El Rio Substation Project

Final Initial Study and Proposed Mitigated Negative Declaration •
State Clearinghouse Number 2023090056 •
November 2023

The Draft IS/MND for the proposed project was circulated for a 30-day public review period (September 5, 2023 to October 5, 2023). During the public comment period, SMUD received four comment letters that pertained to the proposed project (see Table 2-1).

Figure 2-1. Conceptual Substation Plan

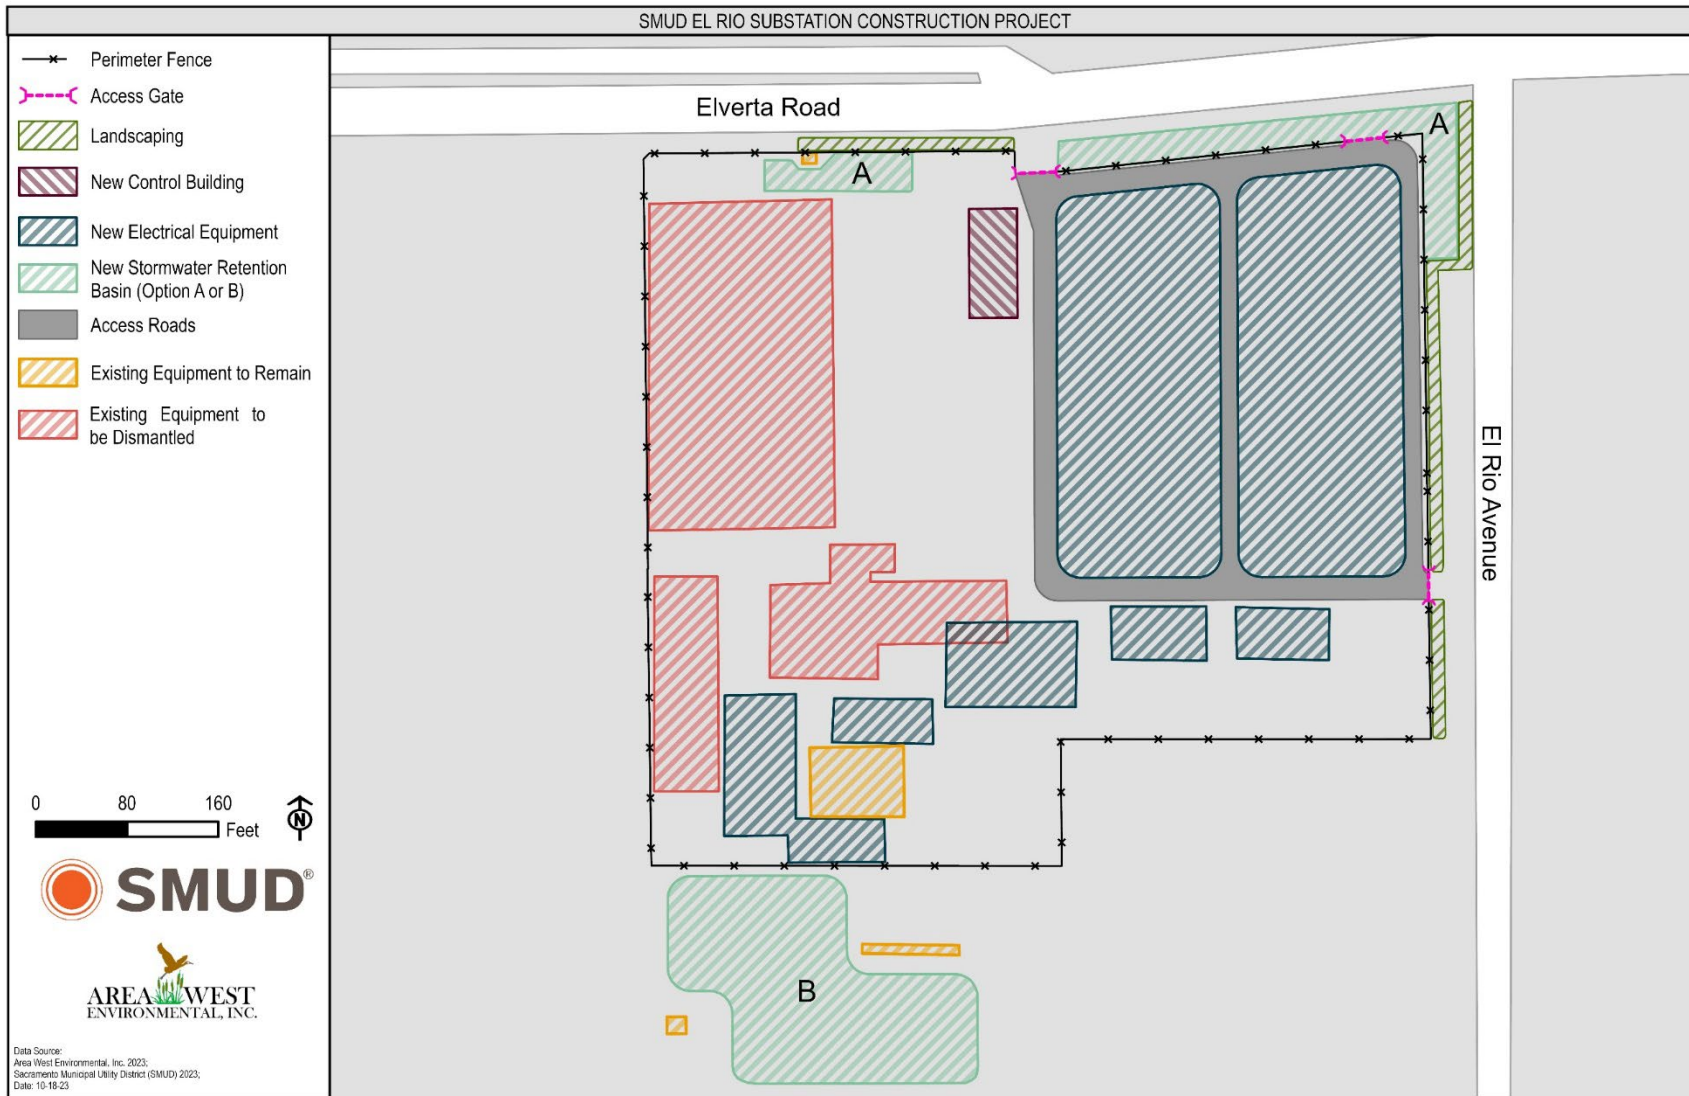
- 2-1 The comment is inquiring about the use of and need for the proposed access gate on El Rio Avenue, which is not a county-maintained road.

- 2-2 The comment requests more information regarding impacts from the proposed retention basin for the project. Additionally, the commenter requests monitoring of the retention pond for hazardous waste.

Figure 2-4 Conceptual Substation Plan on page 13 of the Draft IS/MND has been updated to show options for stormwater drainage and revision to the El Rio Avenue gate. The revised figure is provided below.

The location of the El Rio Avenue access gate has been updated on Figure 2-4; see Section 3 *Changes to Draft IS/MND Text* below.

The description of the retention basin and optional locations for stormwater retention and treatment have been updated for clarity. See Section 3 *Changes to Draft IS/MND Text* below for the updated text and revised Figure 2-4.

The text on page 14 of the Draft IS/MND describing the stormwater drainage has been revised as follows.

The substation would be designed such that on-site runoff would be collected into an underground storm drain pipe system and a stormwater retention basin. The stormwater retention basin would be constructed south of the existing Elverta Substation or within the El Rio Substation footprint after the Elverta Substation is dismantled and in accordance with site drainage design requirements. Figure 2-4 shows optional locations for the retention basin or bioretention basin south of the existing substation (Option B) or along the north side of the new and existing substation (Option A). In order to minimize drainage impacts from the increased amount of non-permeable surfaces (estimated to be 60,000 square feet), the proposed on-site retention basin would collect stormwater in the basin, allowing pollutants to be captured by vegetation and the water to percolate into the soil. If constructed within the substation property, the bioretention basin or retention basin would collect stormwater and allow pollutants to be captured by vegetation before entering the existing roadside stormwater collection system. If the stormwater retention basin were constructed outside of SMUD's current easement area on the WAPA-owned parcel, SMUD would modify the existing easement with WAPA to include the basin area.
